FIGENSCHOU et al.
Appl. No. 10/560,925
January 14, 2008

AMENDMENTS TO THE DRAWINGS

REMARKS/ARGUMENTS

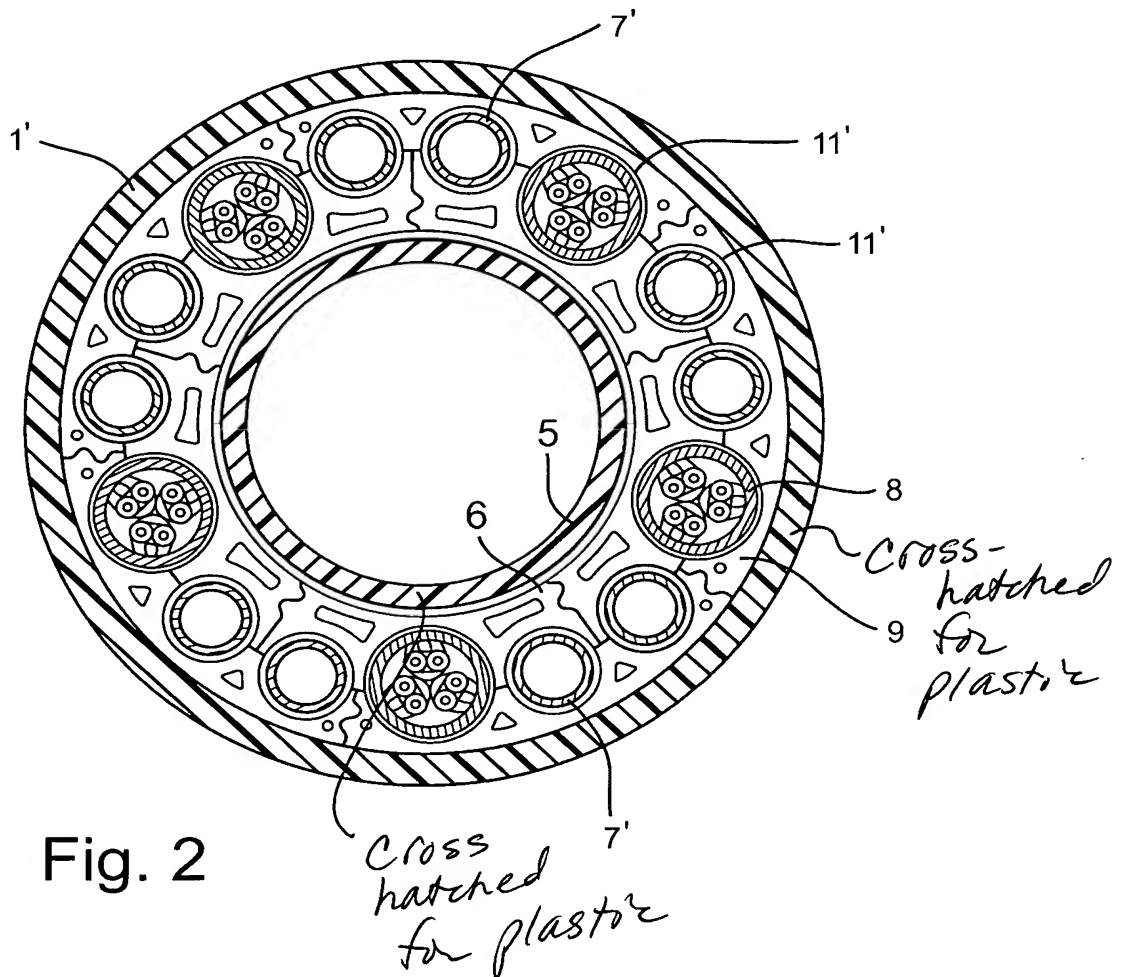
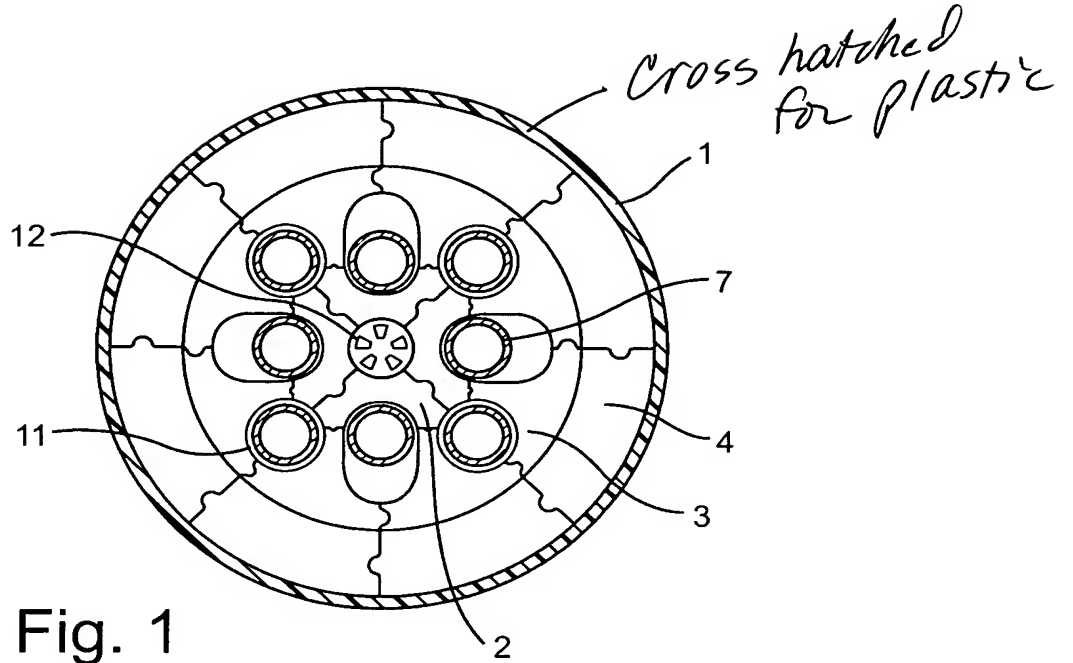
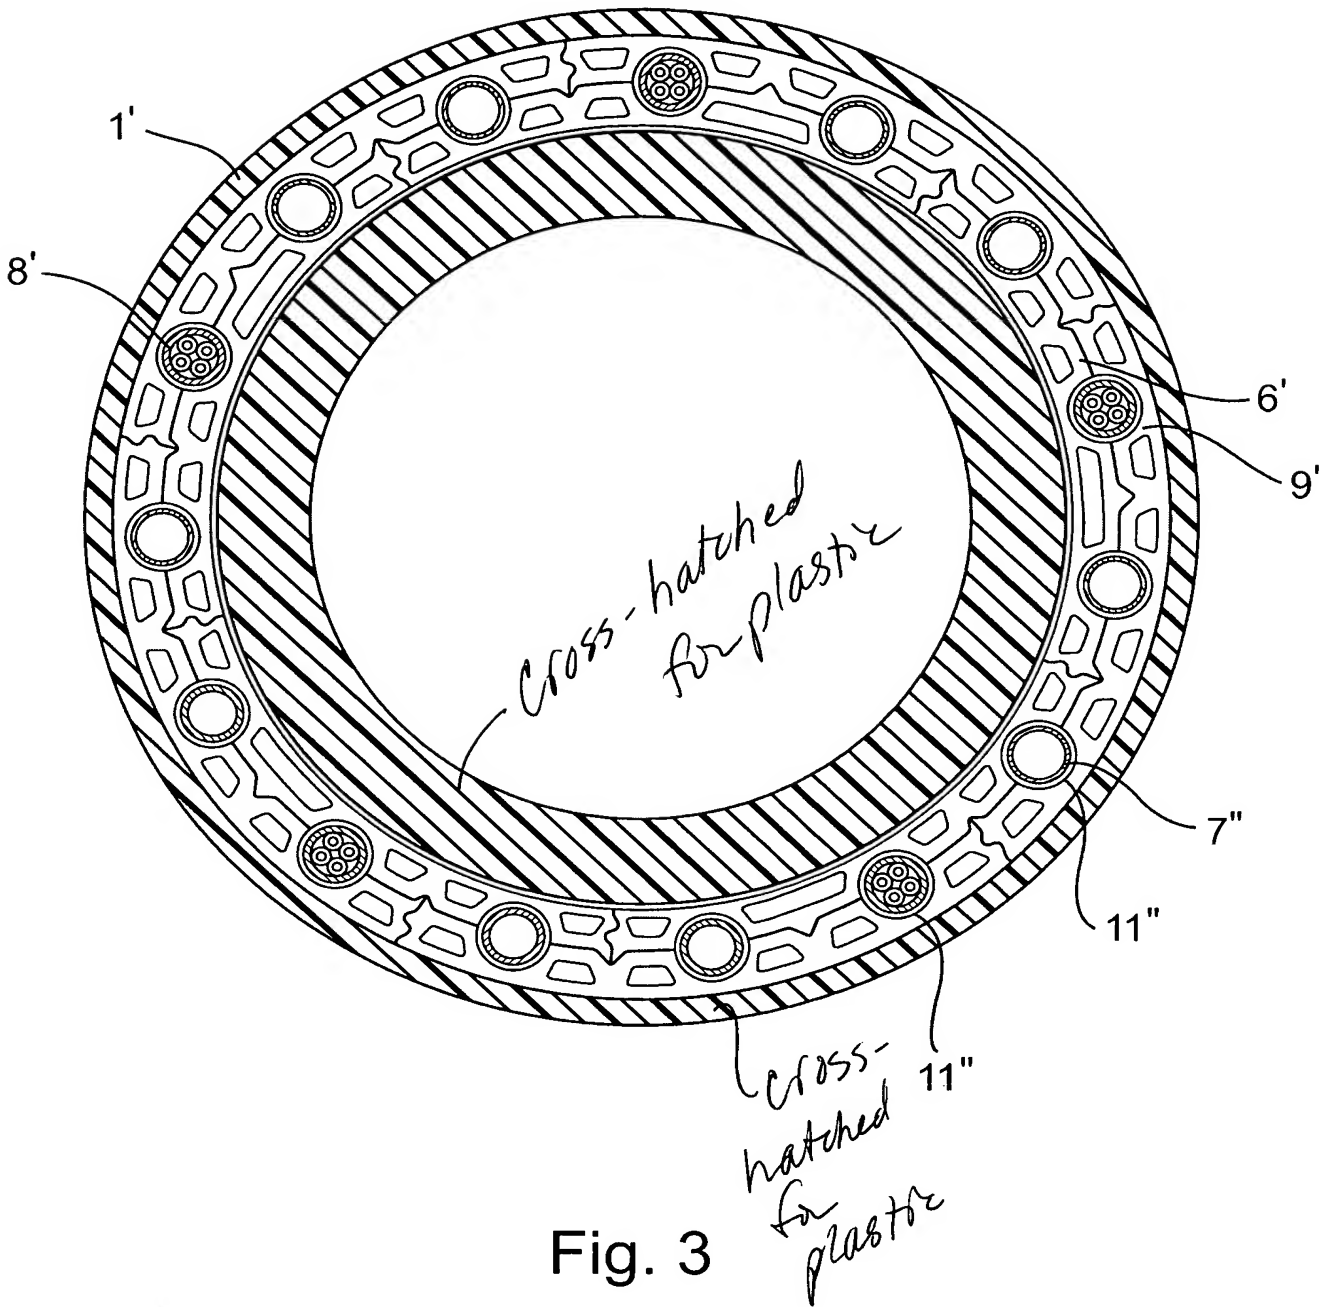
The drawings were objected to because Figures 1-3 lacked proper cross-hatching indicating the types of materials. In particular, the Examiner indicated that the cross-hatching to indicate the conductor and insulation materials is improper. At the outset, it is respectfully noted that the cross-sectional illustrations provided by applicant are consistent with that provided, e.g., in the primary reference cited against the claims, Haug (USP 5,813,106). Furthermore, the cross-hatching provided, for example, for electric conductor 8 and pipe 7 is not only consistent with the applied art but proper because the simple cross-hatching used therefore is proper for cross-hatching of a non-descript, unidentified material. It is noted that while the pipes 7 and electrical conduits 8 are well known in the art, as mentioned the specification, the particular material thereof is not described and is not critical to the invention disclosed herein.

In view of the Examiner's comments during the interview, the corrected drawing submitted herewith corrects the cross-hatching for the outer sheath 1 to be plastic and central fluid flow line 5 to be plastic as disclosed. The filter material 2,3,4,6, and 9 is disclosed as being plastic but following the telephone interview with the Examiner it is

understood that it is acceptable for those parts not to be cross-hatched because this will detract from a review of the illustration and because conventionally in this art filler material is not cross-hatched in cross-sectional views. The simple single line cross-hatching has been maintained for conduit 7 and 8 consistent with the fact that the material of these tubes is not critical but to show that in fact a structure is present rather than a hollow space. It is believed that the revised drawings are consistent with the disclosure, consistent with the illustrations typically provided in this area of technology and are therefore proper.
